PROJECT 93L-EWL-132, 2721EA EMERGENCY DRAINFIELD REPLACEMENT

ENGINEERING CHANGE NOTICE

Proj. ECN L-132-8

MODIFY DRAWINGS AND SPECIFICATIONS TO PROVIDE PUMP AND 2" LINE FROM 2711E TO THE L-132 DOSING CHAMBER.

TYP RAILROAD CROSSING

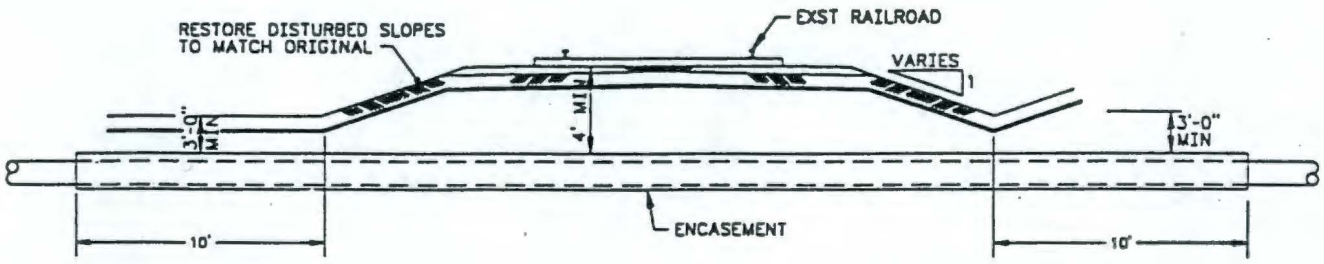
KAISER ENGINEERS HANFORD	ENGINEERING CHANGE NOTICE SKETCH					
Ref. Dwg.	Sh.	Rev.	Prepared By	Checked By	ECN No.	Page
1-2-817615	1	0	JD AXFORD	RHollenbeck 5-12-90	L-132-8	4/18

2607EP FILTER INSTALLATION

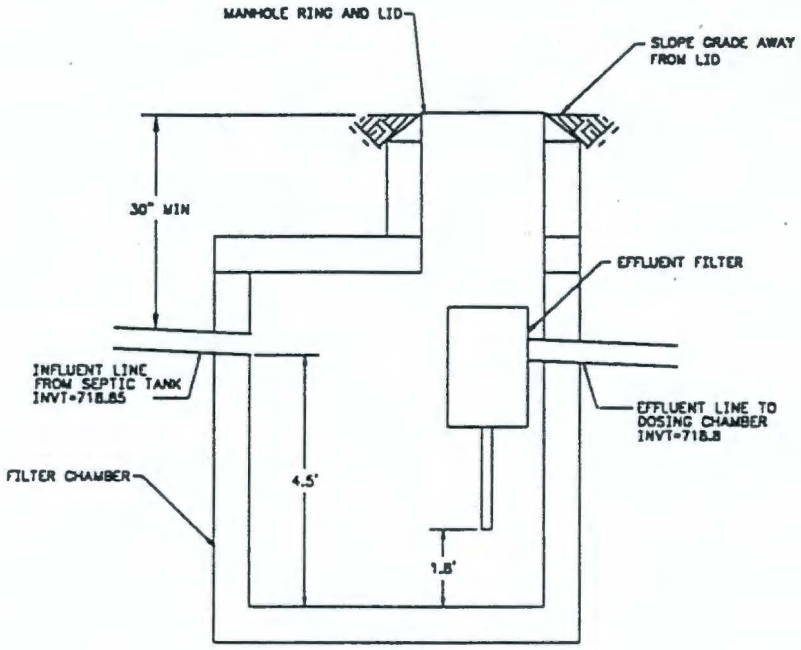
KAISER ENGINEERS HANFORD	ENGINEERING CHANGE NOTICE SKETCH					
Ref. Dwg.	Sh.	Rev.	Prepared By	Checked By	ECN No.	Page
1-2-817616	1	0	JD AXFORD	R Hollenbeck 5/12/94	L-132-8	5/18

2607EO PUMP INSTALLATION

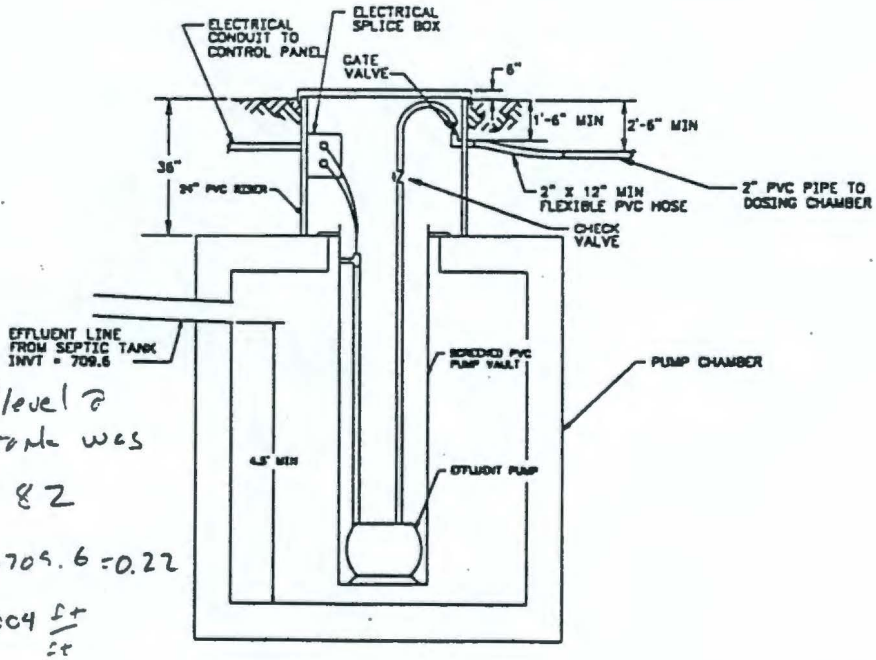
Liquid level @ septic tank was 709.82

709.82 − 709.6 = 0.22

@ 0.004 ft/ft

w/i SS

KAISER ENGINEERS HANFORD			ENGINEERING CHANGE NOTICE SKETCH			
Ref. Dwg.	Sh.	Rev.	Prepared By	Checked By	ECN No.	Page
H-2-817614	1	0	JD AXFORD	R Hollenbeck 5/12/94	L-132-8	8/18

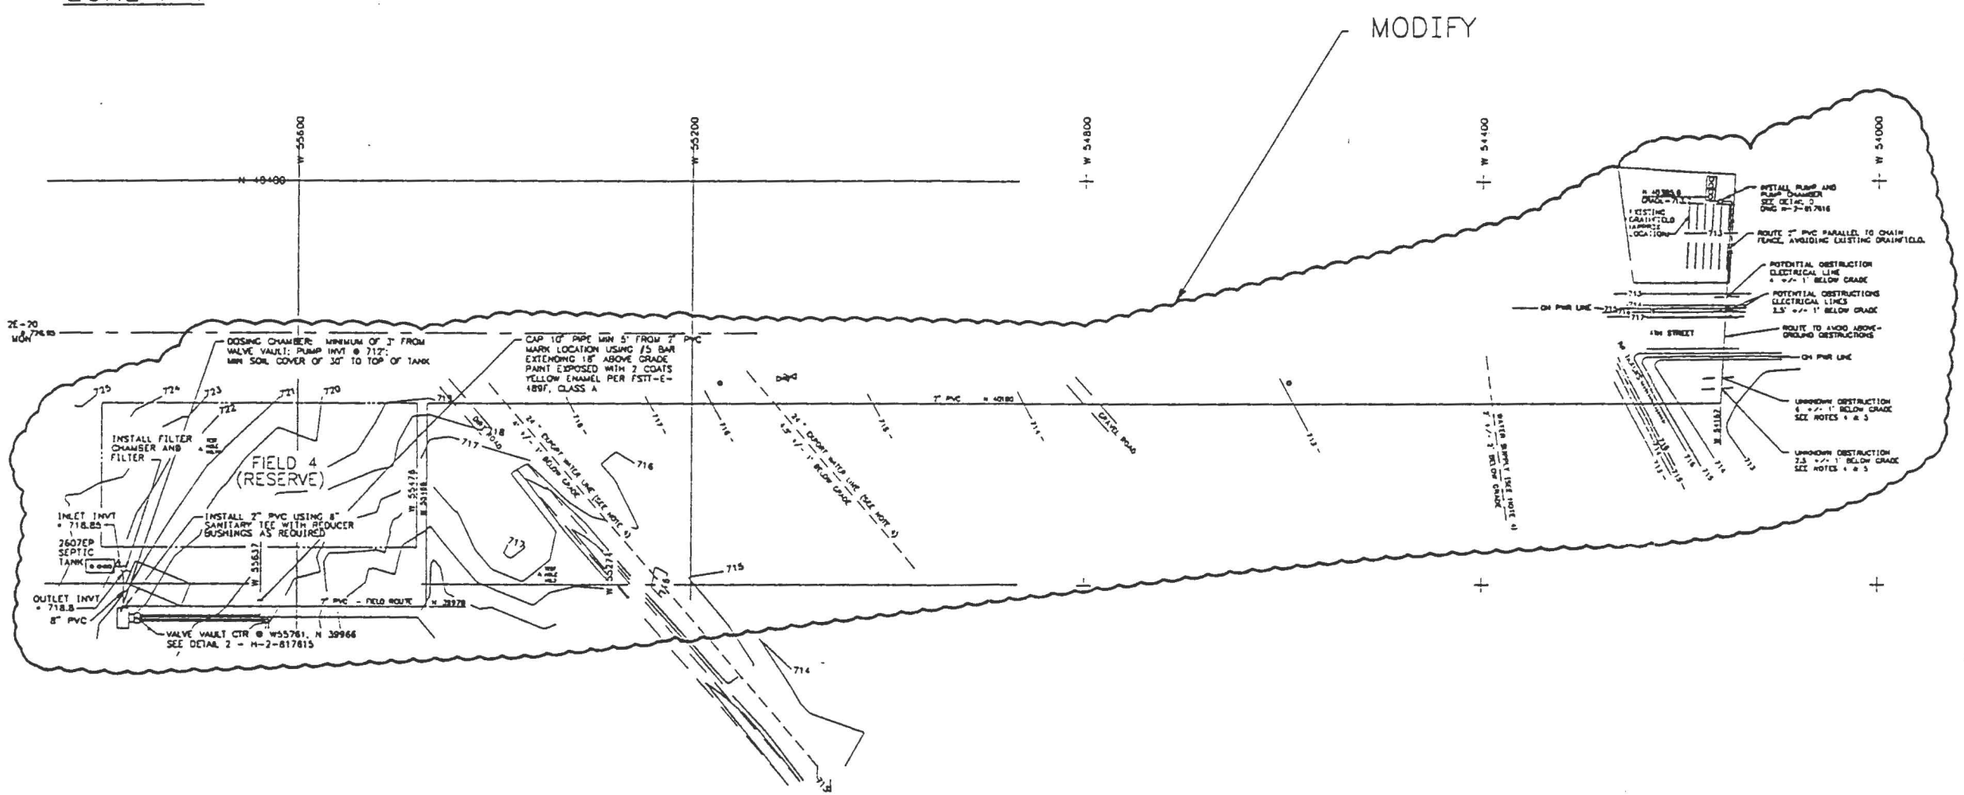
MODIFY

1. SEE DWG H-2-817618 FOR FIELD DETAILS.
2. MAINTAIN MINIMUM 20' ~~SEPARATION BETWEEN EXPORT WATERLINES~~ & ALL CONSTRUCTION ACTIVITY, EXCEPT AT THE 2" PVC CROSSING.
3. EXCESS EXCAVATED MATERIAL SHALL BE DISTRIBUTED & STABILIZED IMMEDIATELY SOUTH OF FIELDS 1 AND 2 AS DIRECTED BY KEH.
4. THE TOP OF THE 2" PVC SEWER SHALL PASS A MINIMUM OF 2' BELOW BOTTOM OF ALL WATER LINES
5. AT LEAST ONE OF THE TWO UNKNOWN OBSTRUCTIONS IS A WATER LINE.

ADD

PUMP CONTROL RACK (SEE NOTE 11)

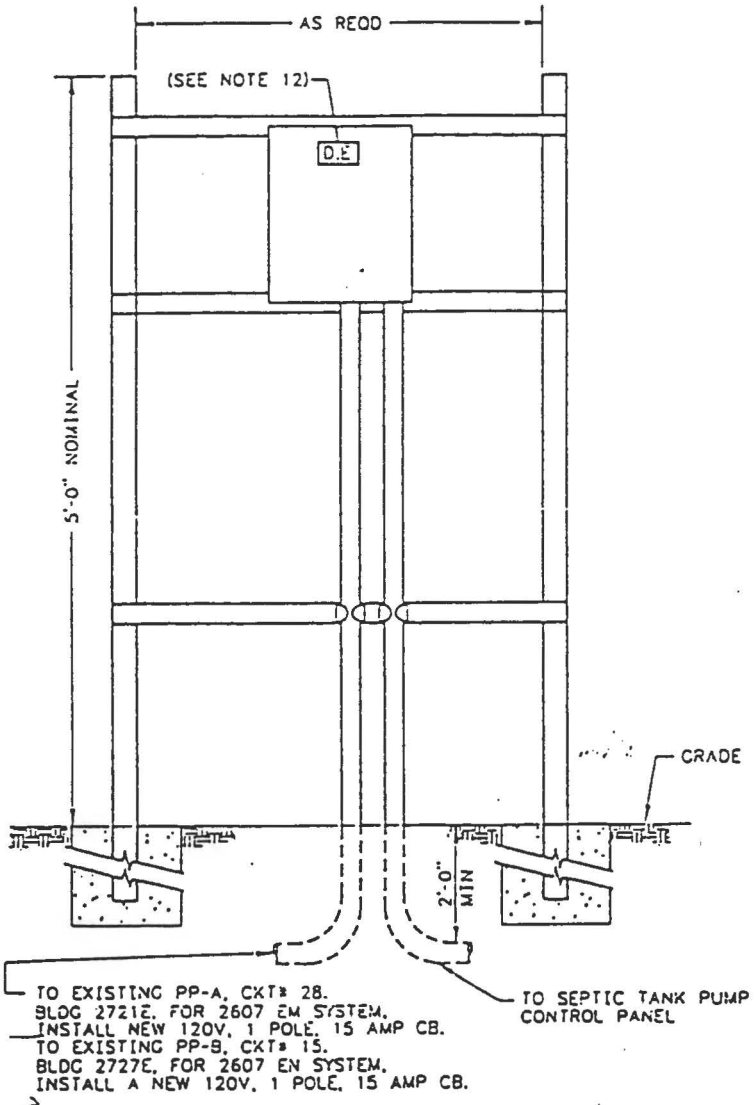
ECN No. L-132-8		Page 7/18	
Ref. Dwg. H-2-817617		Sh. 2	Rev. 0
Prep. By J.D. Axford	Chkd. By R Hollenbeck 5/12/92

PUMP C

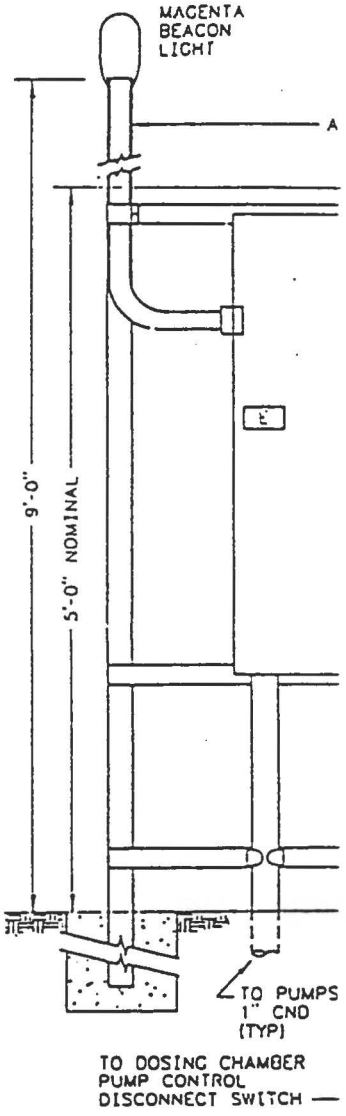
ADD:

TO EXISTING PP-13, BLDG 2711E.
FOR 2607EO SYSTEM, INSTALL
NEW 120V, 1 POLE, 20 AMP CB.
